NOTICE TO CONTRACTOR
All construction must comply with current NC Building Codes and is subject to field inspection and verification.
APPROVED
Limited building only review
Permit holder is responsible for full compliance with the code
09/23/2022
Harnett COUNTY NORTH CAROLINA

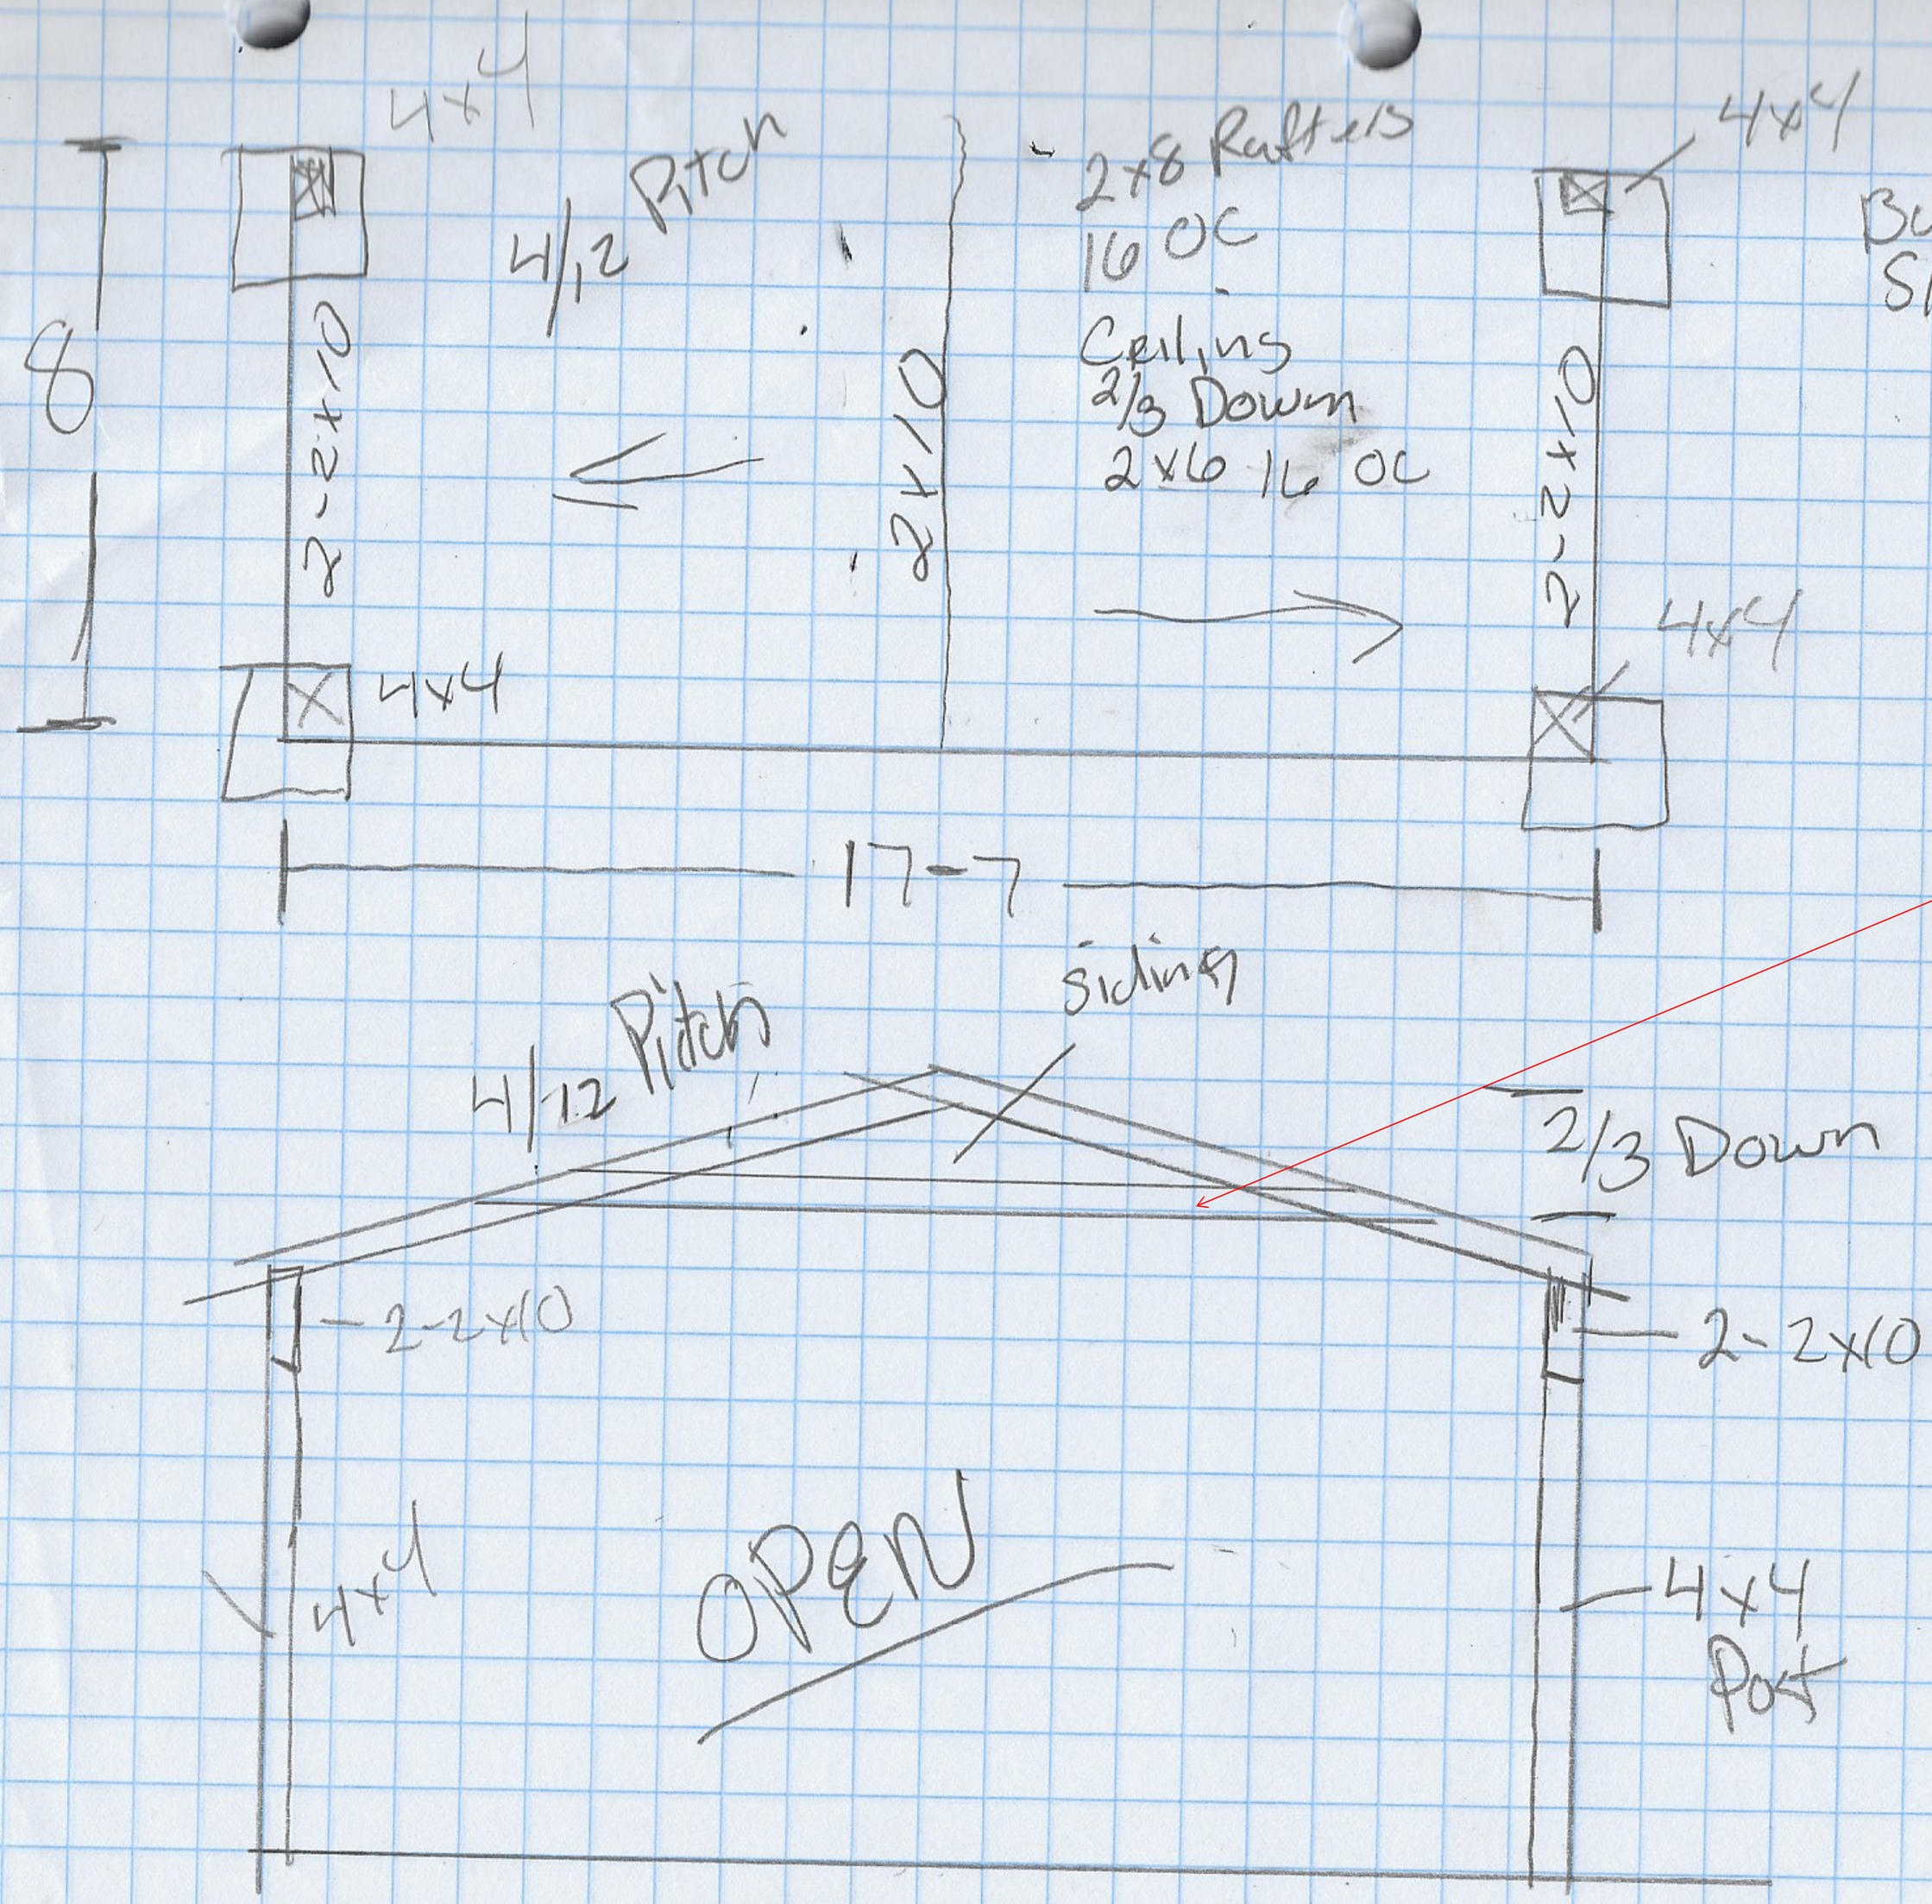
Built on Existing
Slab adding footing
20x20x12

Rafter span may not exceed 16'11" and must be in the lower 1/3 of rafter span as noted above
